Technical Bulletin - Safety Alert

TB Number: 102
Date Issued: 04/15/2016
Expiration Date: None

Subject/Key Words:	GAMA Module Heater Compartment Leak Containment CIP			
Classification:	<input checked="" type="checkbox"/> Informational	<input type="checkbox"/> Mandatory	<input checked="" type="checkbox"/> Safety Alert	<input type="checkbox"/> Preventive Maintenance Impact
	<input type="checkbox"/> Warranty Impact	<input type="checkbox"/> Purchase Parts	<input type="checkbox"/> No Charge For Parts expires ___ / ___ / ___. Reference this TB# when ordering NC parts.	
Application:	GAMA Heated Recirc Modules

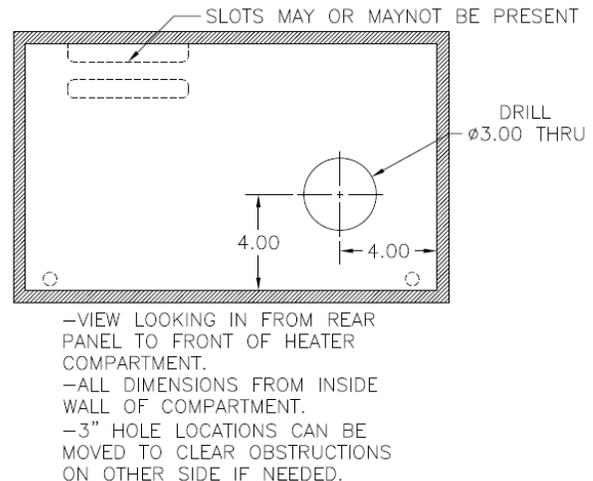
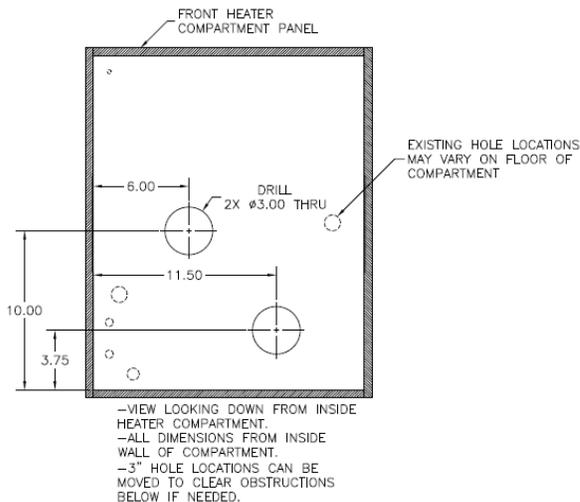
Issue: On many older GAMA modules chemical leaks in the heater compartment will not drain into the plenum quickly enough through the small drainage hole provided. When a substantial leak occurs, as in the case of a line breaking or fitting failure, chemical can back up inside the compartment and leak from the compartment to outside the module through the door and other openings.

Solution: Add larger drainage holes to the floor, as well as front panel of the heater compartment. This will allow the chemical to drain from the compartment to the plenum at a rate which will prevent any backup and leakage outside of the module. This modification also brings the module closer to the current module configuration in use today. The drawings below show the location of the new drilled holes. Technicians making this modification should use these drawings as a general starting point. The location can be moved provided the holes are still drilled on the same panels as shown.

Note: Locate the front wall through hole as low as possible to augment drainage as well as venting. Although there are safeguards to detect leaks that will disable pumps and heaters, this improvement will aid in the rapid draining of the heater compartment to promote any circulation system leak or breach to remain contained within the chemical module. All new builds will incorporate rapid drainage designs to all GAMA heater compartments.
